PLANNING

Project **7 Warwick Court**

Drawing Title **Demolition & Proposed Ground Floor Plan**

Drawing No. **P_01** Rev. **D**

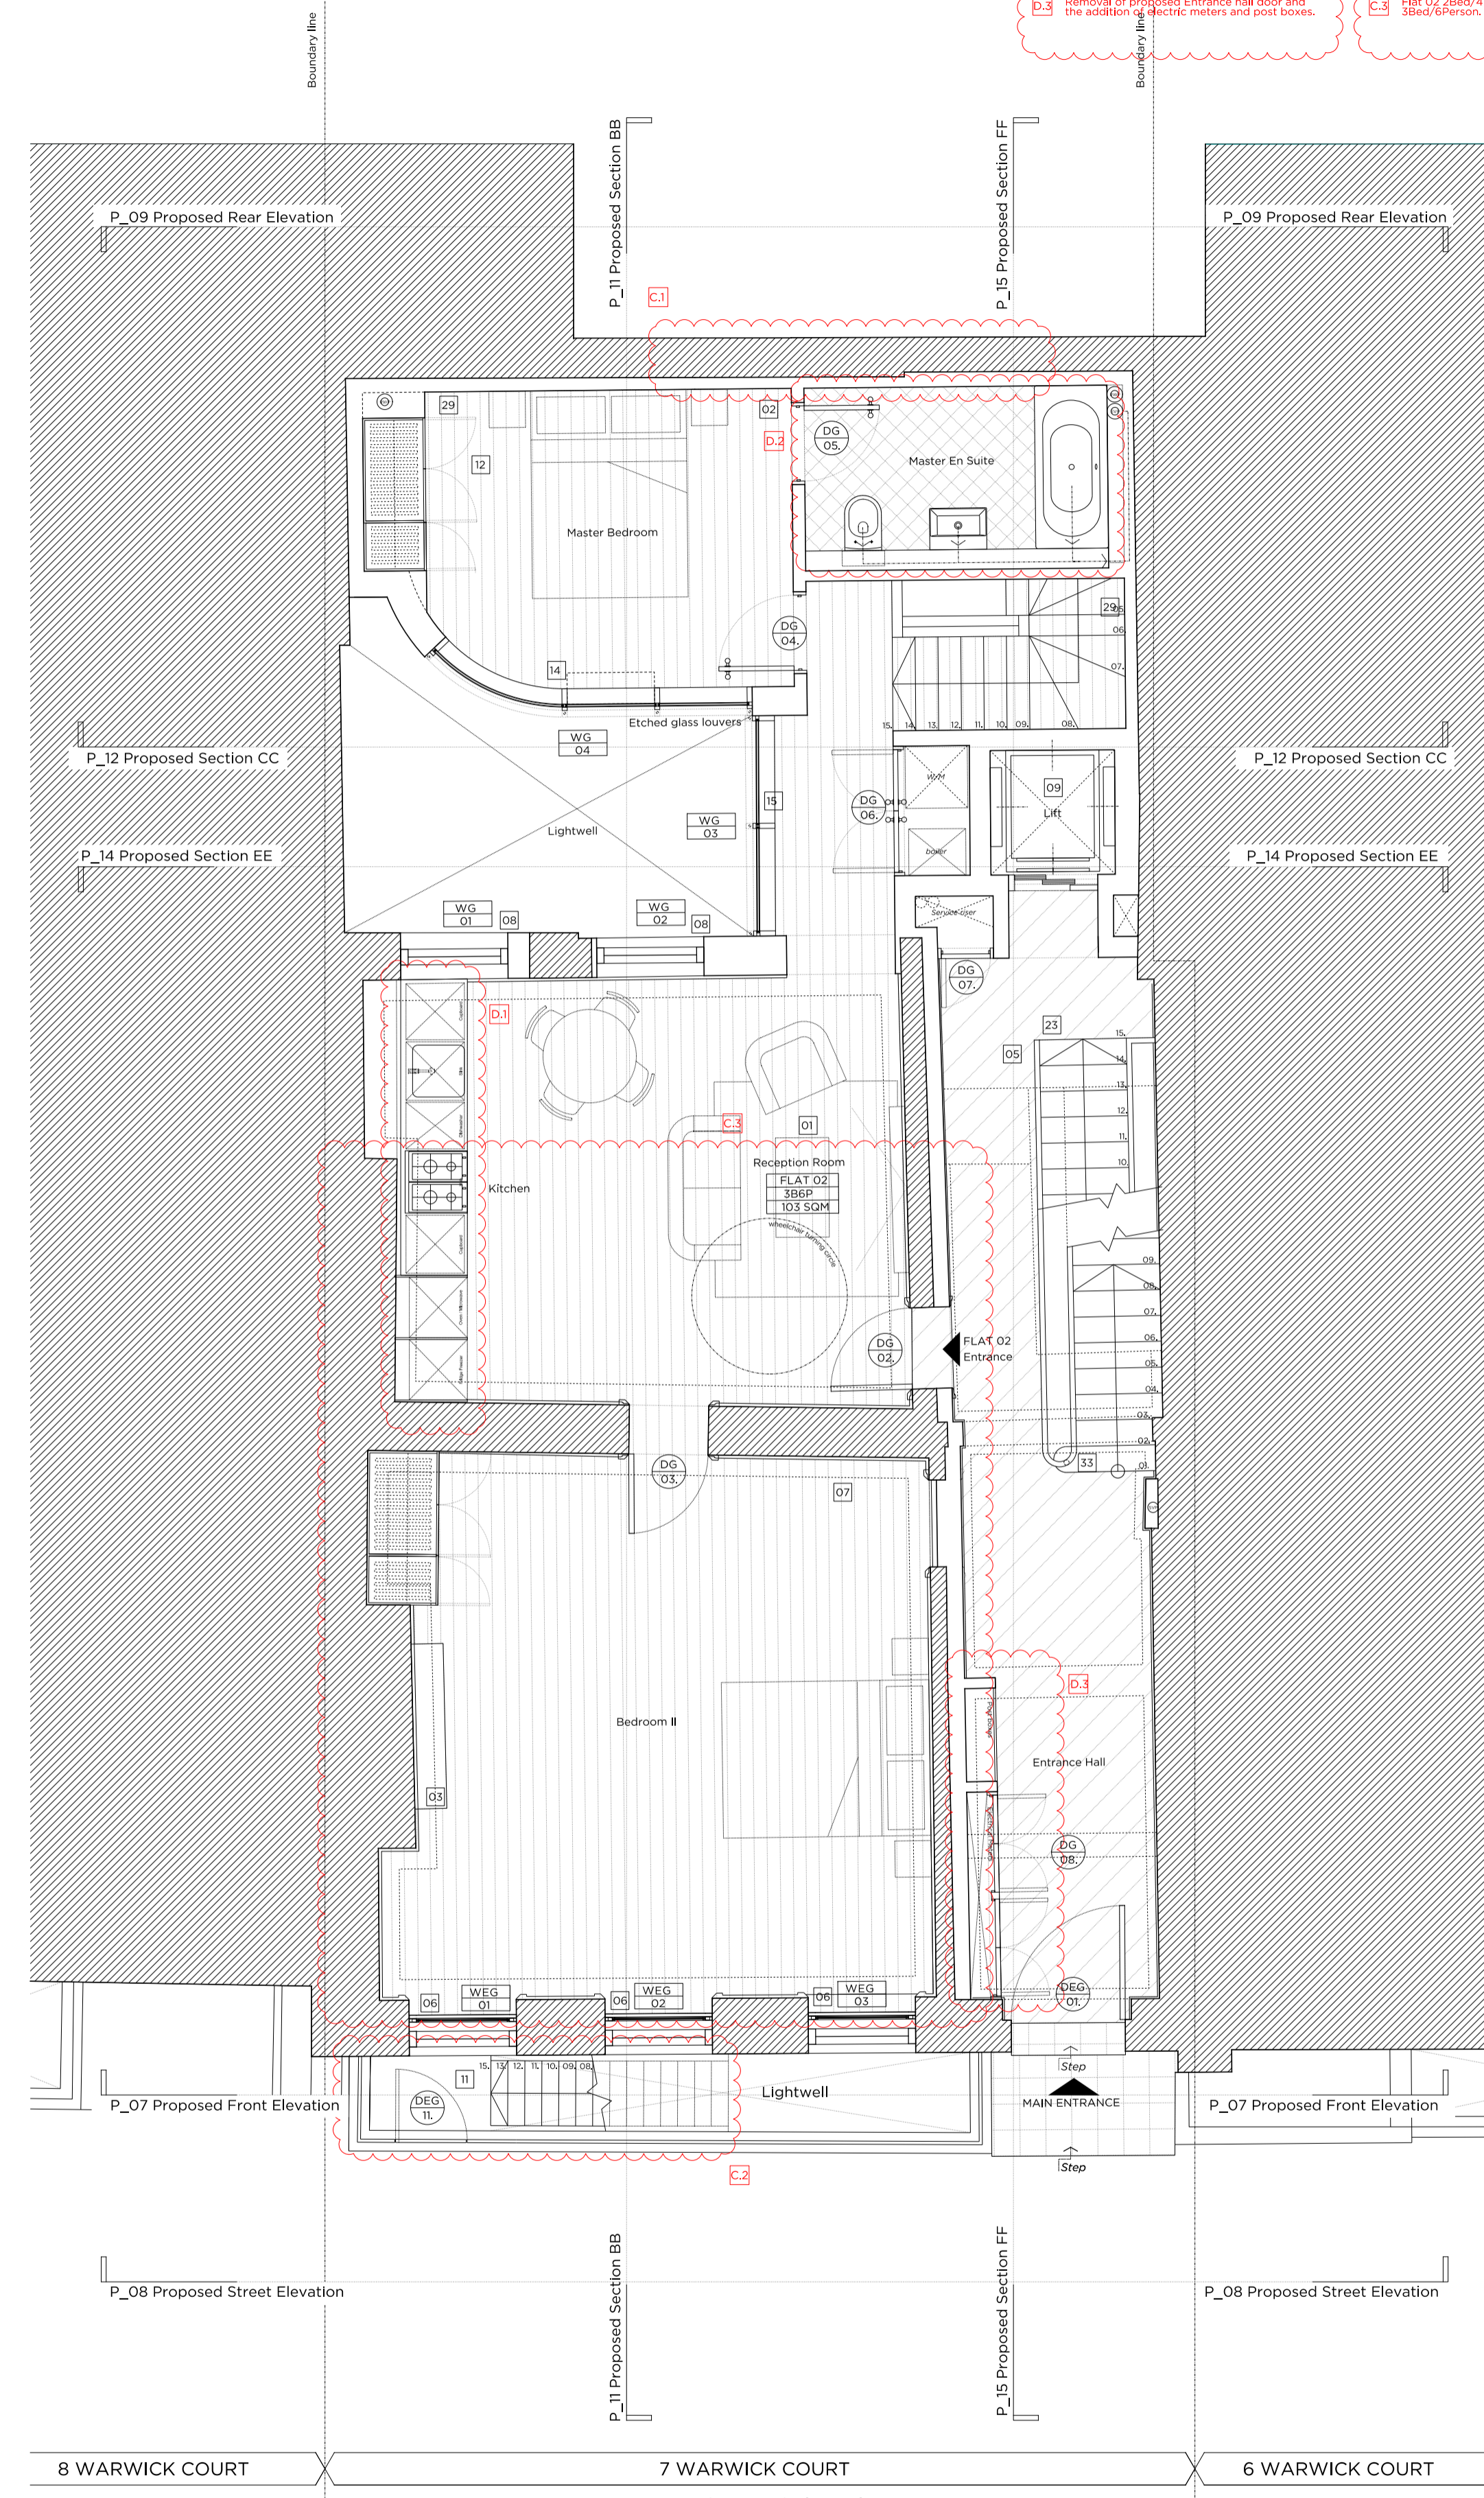
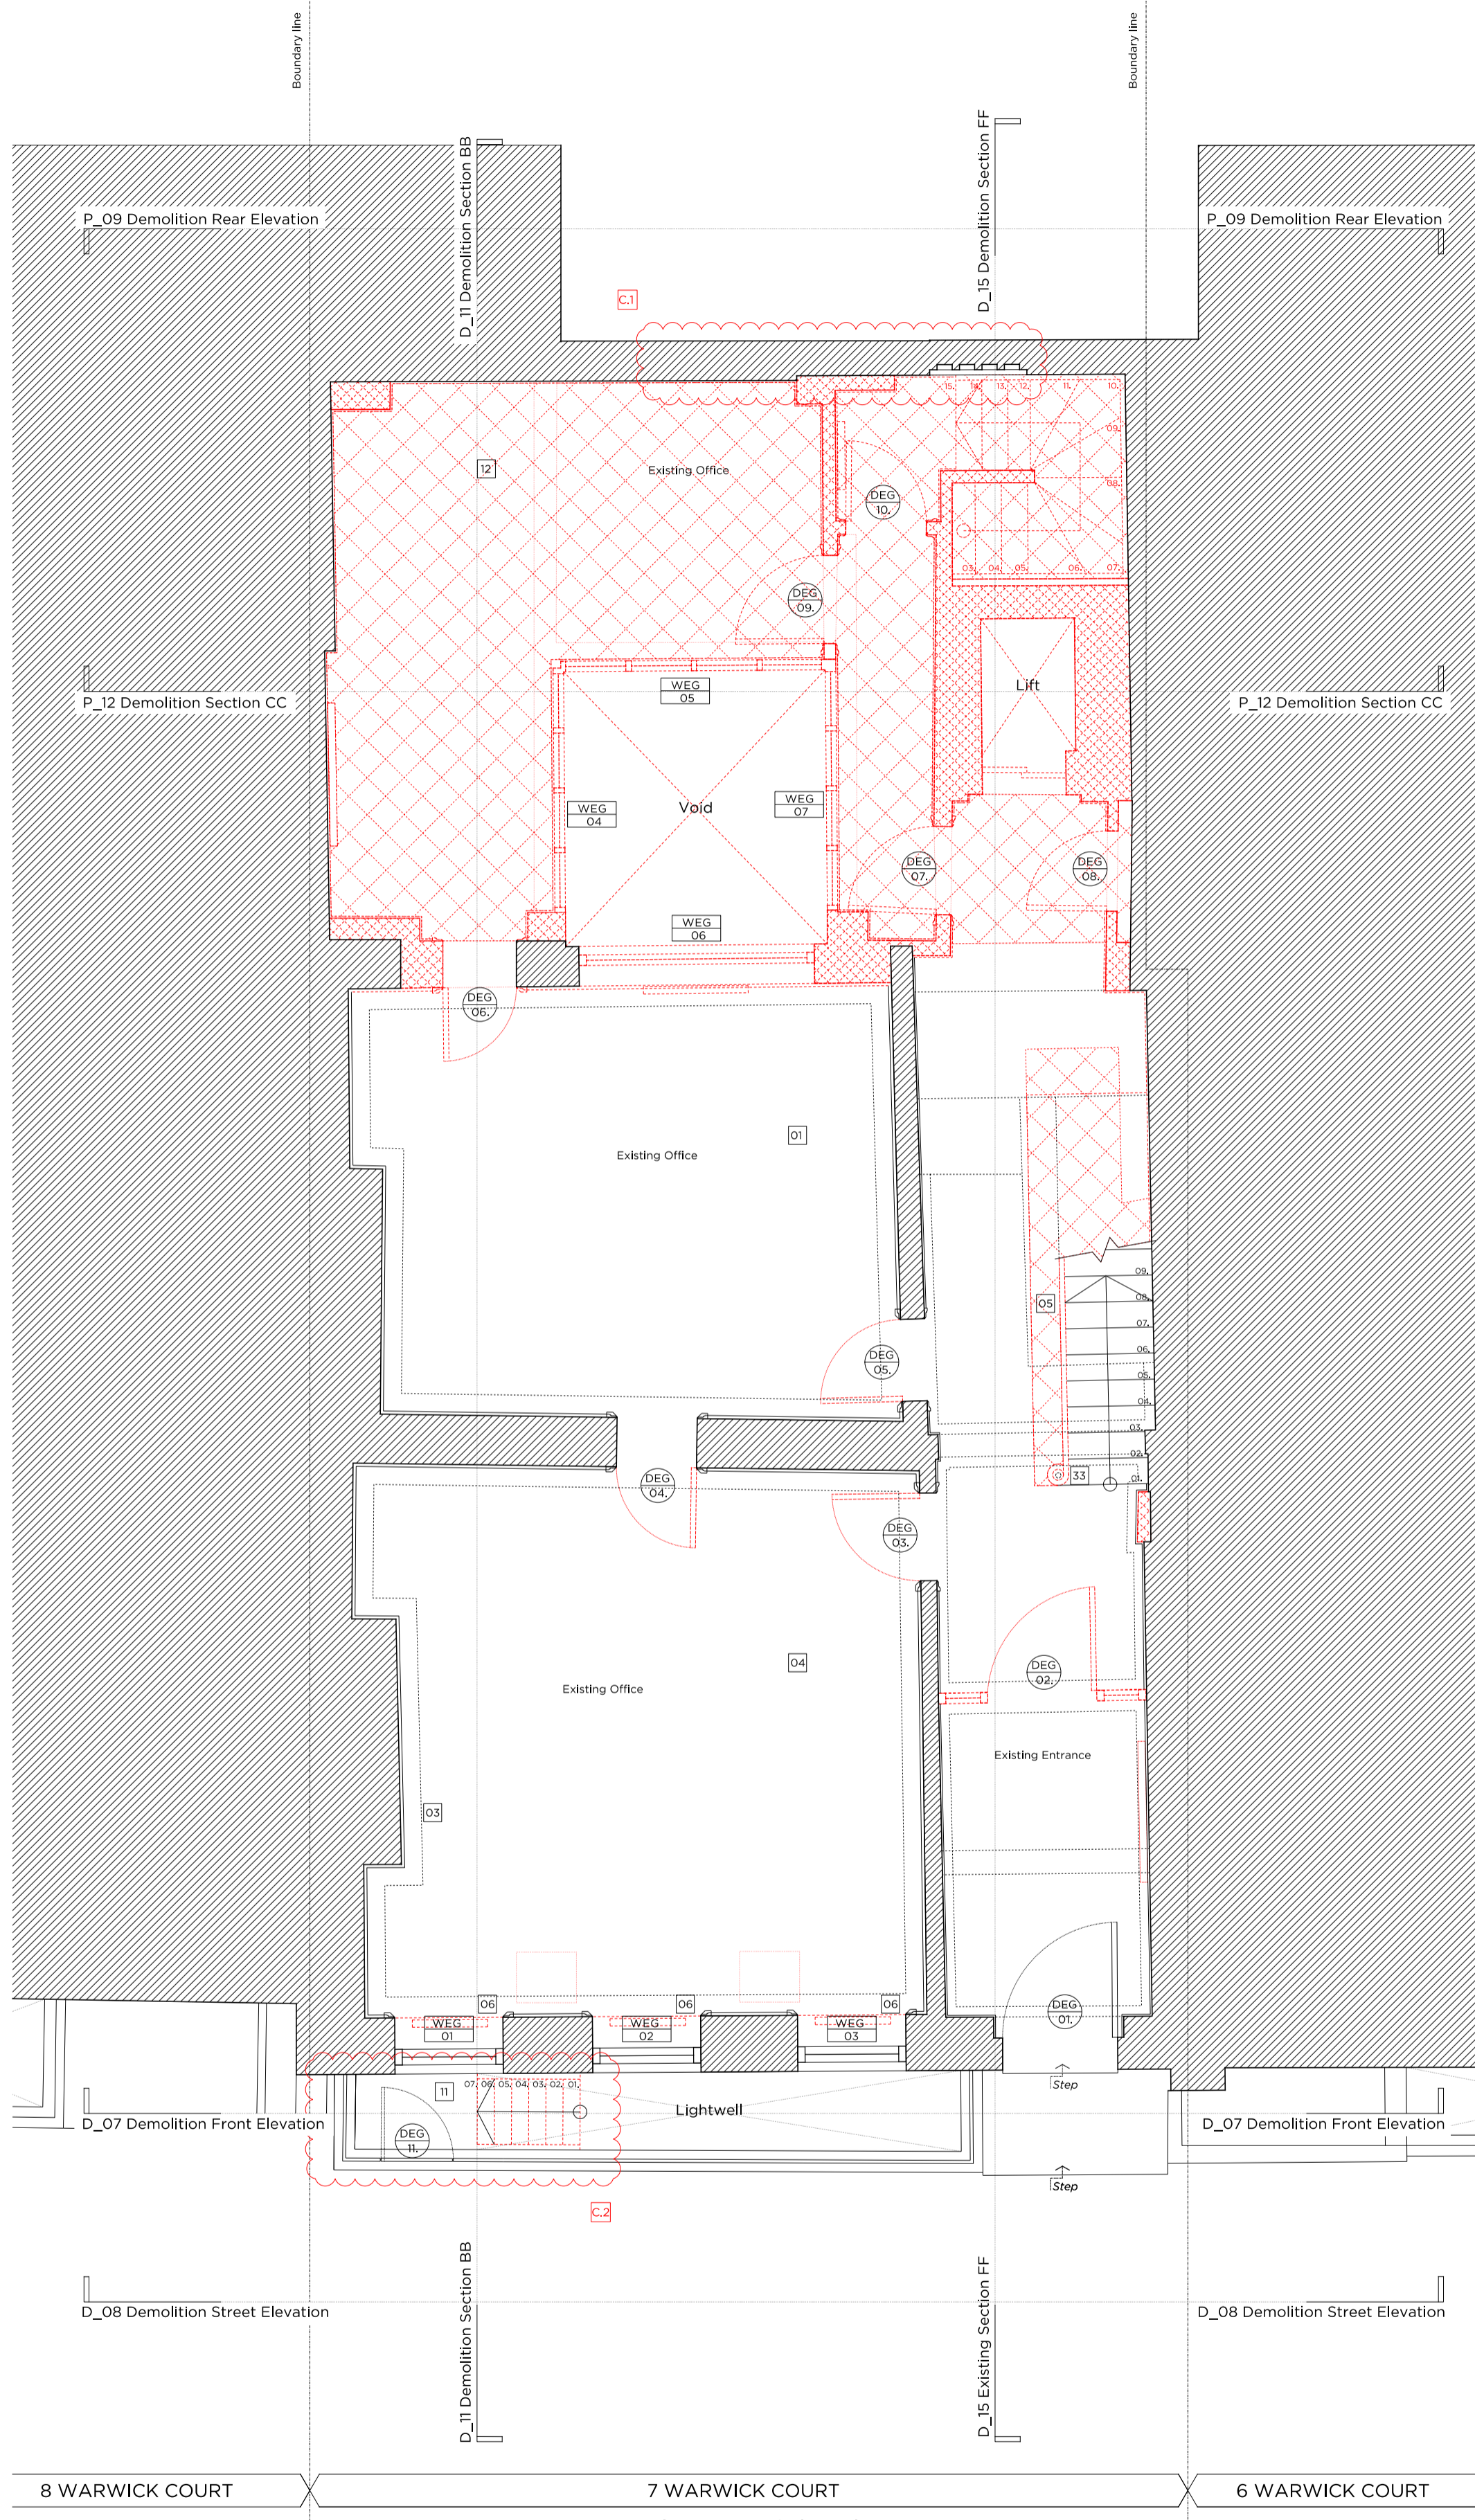
- B. Revision Notes:**
- 1. Proposed Kitchen update.
 - 2. Proposed Master Ensuite layout update.
 - 3. Removal of proposed Entrance hall door and the addition of electric meters and post boxes.
- C. Revision Notes:**
- 1. Window in rear wall which has been shown as existing now removed.
 - 2. Railings and lightwell stair to remain in existing position.
 - 3. Rise 02 Stair/Person to become 5Bed/6Person.
